Our Case Number: ACP-323066-25

Re: Gort Town Centre Public Realm Enhancement Project, Gort, Co. Galway
In the townlands of Gort, Co. Galway

Re: Case reference: JP07.323066

Gort Town Centre Public Realm Enhancement Project, Gort, Co. Galway

George Street

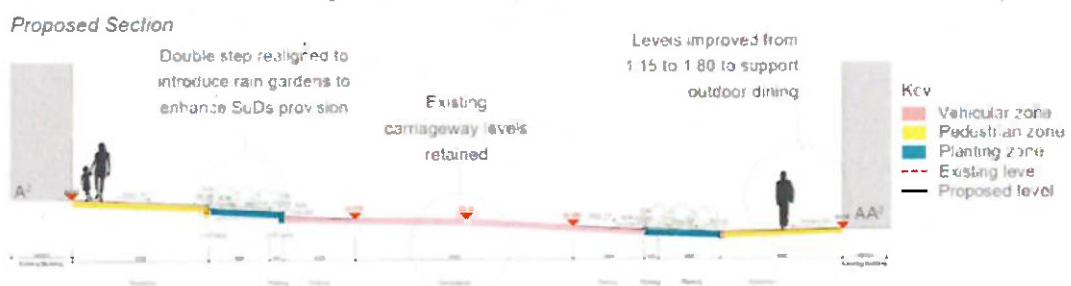
The total width of these arrangements comes to 14 m. An alternative allocation for 14m is 2 x 2m footways, 2 x 2m cycle tracks and a 6m roadway.

Figure: Extracts from DMURS Showing unsuitable lane widths on arterial roads.

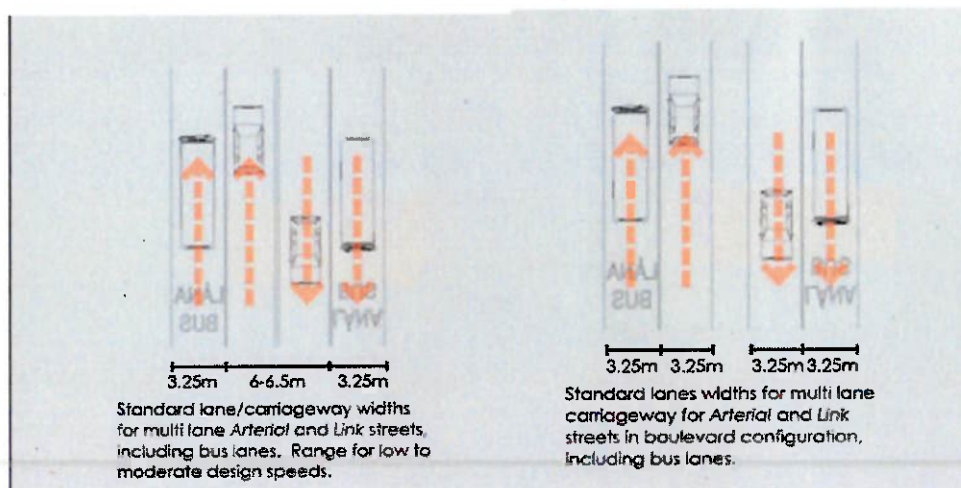
In Appendix P *Gort-Mobility Management Plan* the designers state that they base their proposals on the 2019 (2013) *Design Manual for Urban Roads and Streets* (DMURS). In my view DMURS is not credible guidance for traffic lane widths on urban roads with heavy traffic. I would note that the credibility of DMURS is currently being challenged in two High Court cases to which An Coimisiún Pleanála is a party: H JR 2024 725 Glenveagh Homes (Case Reference: 318687-23) and H JR 2024 1448 BusConnects Cross City Link (Case Reference: HA61.314597).

The rationale for the lane width advice in DMURS is given on page 101.

Figure: Figure 7.16 of UK Manual for Streets (2007)

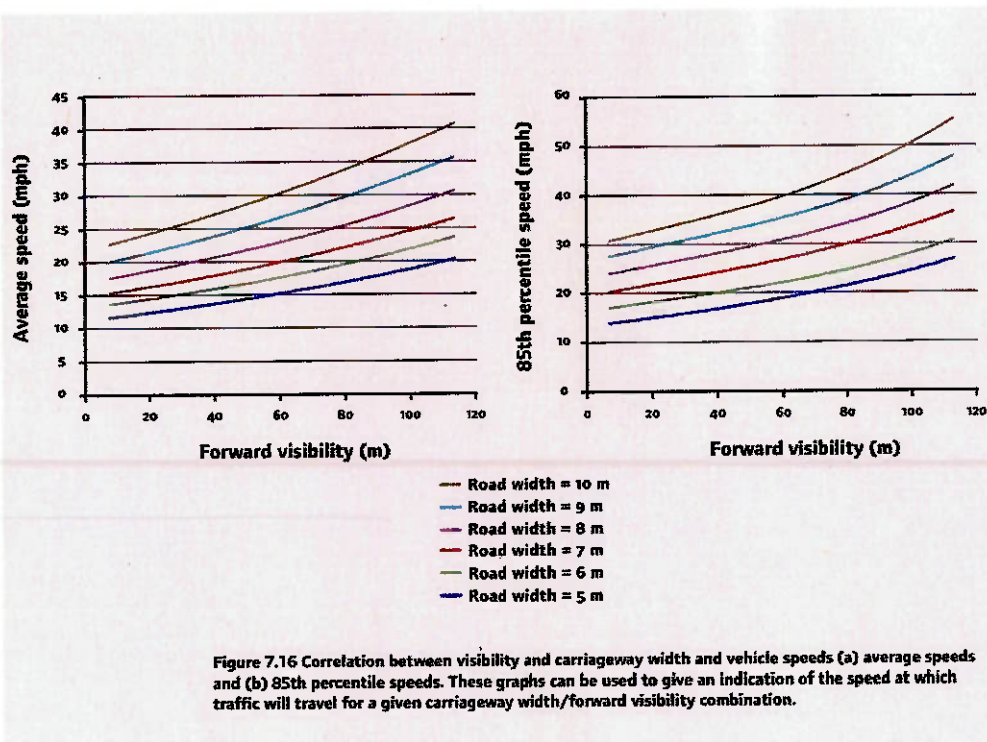
DMURS gives as its source "31 Refer to Figure 7.16 of UK Manual for Streets (2007)". However a review of this diagram from *Manual for Streets* does not support the interpretation given in DMURS. What is shown in the *Manual for Streets* is that the speed reducing effect comes from the combination of lane width and visibility along the axis of the road. The diagrams show that an 8m wide (cycling friendly) road with short forward visibility distances has a better average-speed reducing effect than a 5m wide (cycling hostile) road with long forward visibility distances.

So the designers of the Gort scheme have based their traffic lane widths on a study where most of the sites had less traffic every day than their design is supposed to account for every hour.

Figure 6.3: Junction Turning Counts (Peak Hour – Thursday 1700-1800)

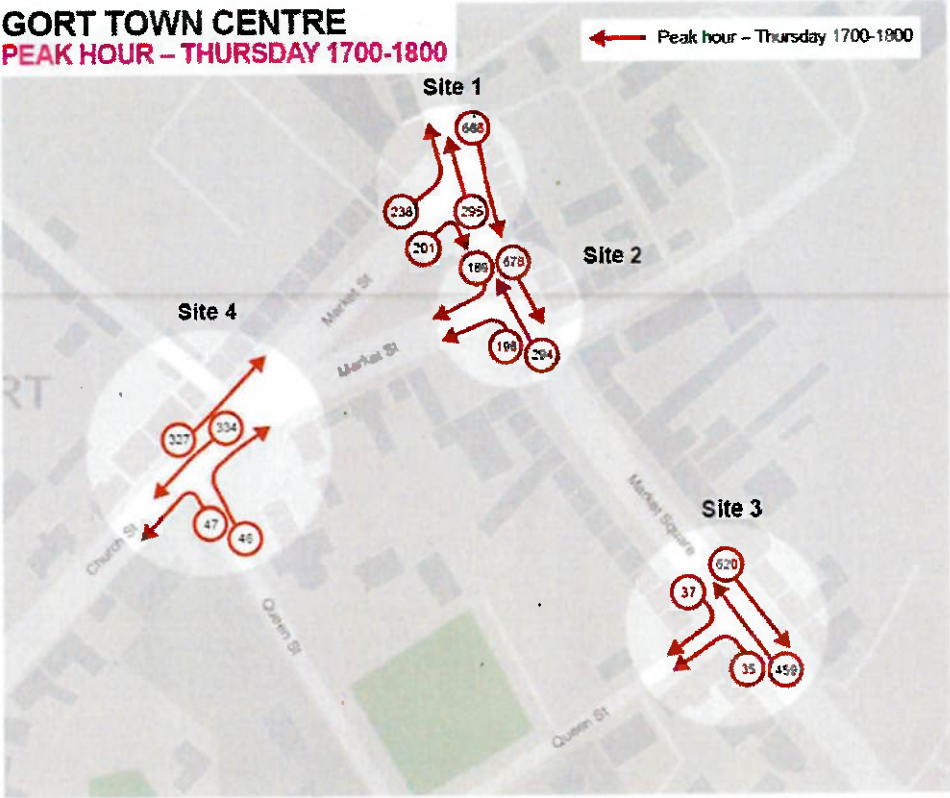
• Site 1 North end of Market St/Crowe Street	1199 pcu/hour
• Site 2 Market Street (south end)	970 pcu/hour
• Site 3 Market Square and Queen Street	1079 pcu/hour
• Site 4 Church Street	754 pcu/hour
